YANKEE NUCLEAR POWER STATION (YANKEE-ROWE)

AMENDMENT TO FACILITY OPERATING LICENSE

Amendment No. 21
License No. DPR-3

ATTACHMENT TO LICENSE AMENDMENT NO. 2 1
CHANGE NO. 1 2 6 TO THE TECHNICAL SPECIFICATIONS
FACILITY OPERATING LICENSE NO. DPR-3
DOCKET NO. 50-29

Figure 8-1

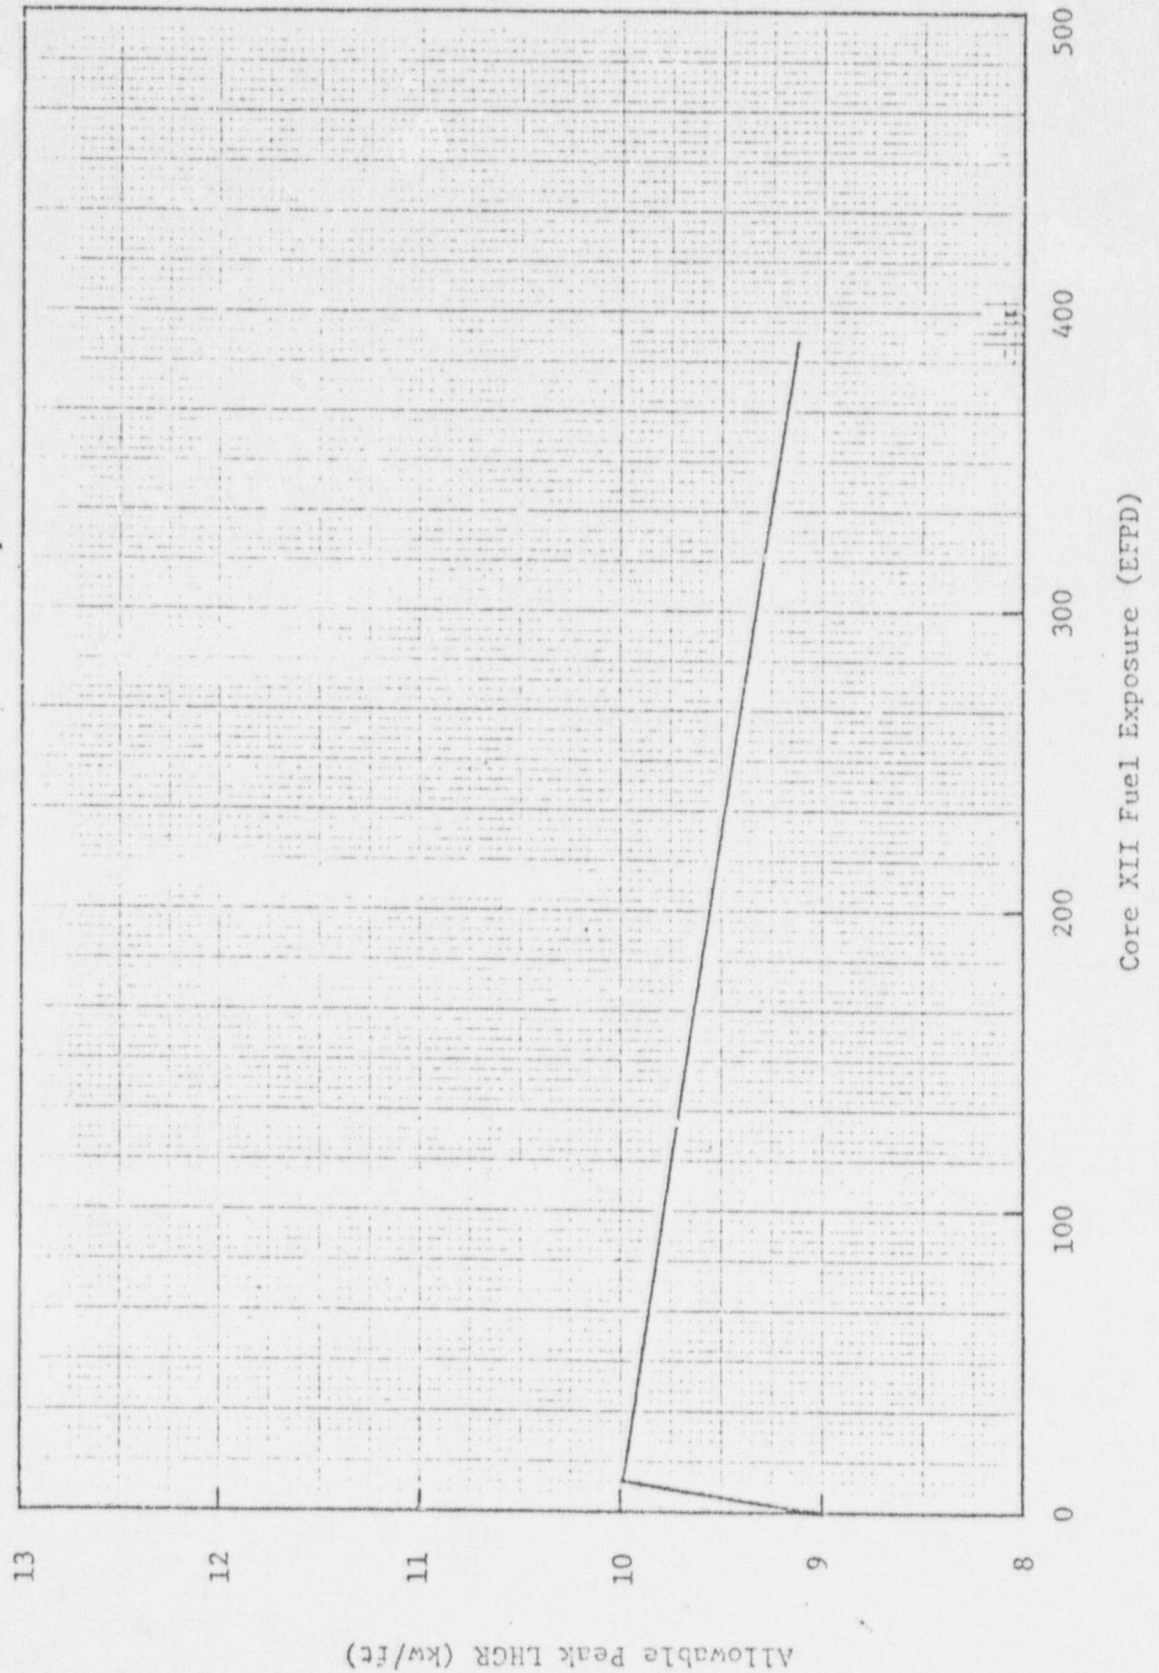
- (1) During steady state power operation, the peak linear heat rate shall not exceed the limits shown in Figure 8-1. With these limits, if full power cannot be attained, the allowable fraction of full power shall be calculated as follows:

where the limiting LHGR is obtained from Figure 8-1.
The peak full power LHGR shall include the following:

Figure 8-2

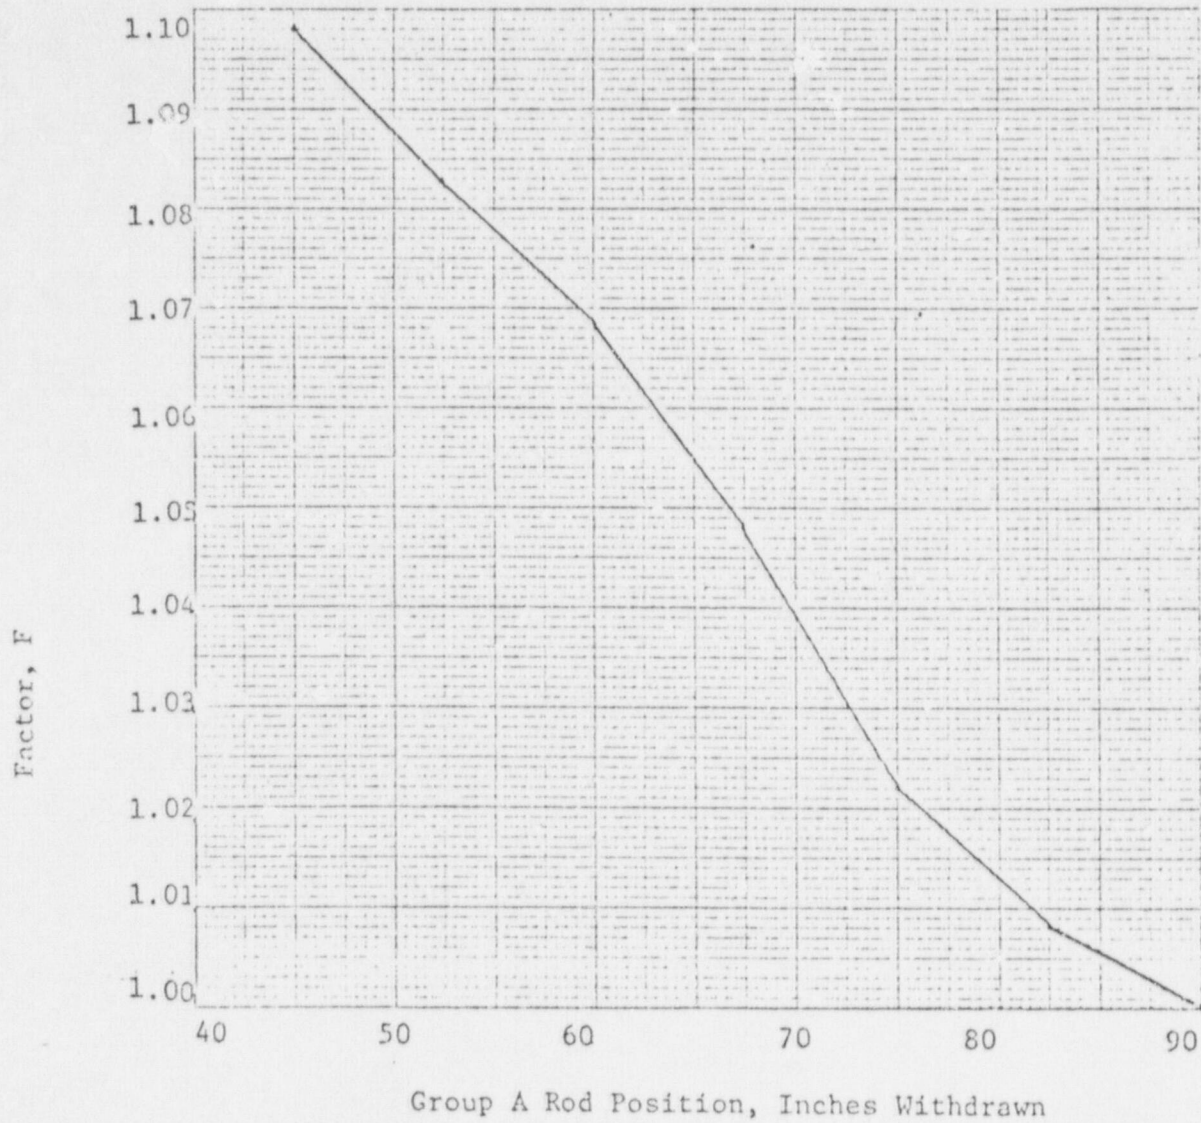
- a) Heat flux power peaking factor, $F_{q,N}^N$ measured using core instrumentation at a power $\geq 10\%$;
- b) Effect of inserting the control bank from its position at the time of measurement to its insertion limit (F_I) as shown in Figure 8-2. The rod insertion limit is shown in Figure 8-3;
- c) Effect of xenon redistribution (1.10);
- d) Flux peaking augmentation factor (power spike) using Figure 8-4;
- e) Shortened stack height factor (1.009);
- f) Measurement uncertainty (1.05);
- g) Power level uncertainty (1.03);
- h) Heat flux engineering factor, $F_{q,E}^E$, (1.04);
- i) Core average linear heat generation rate at full power (4.34 kw/ft).
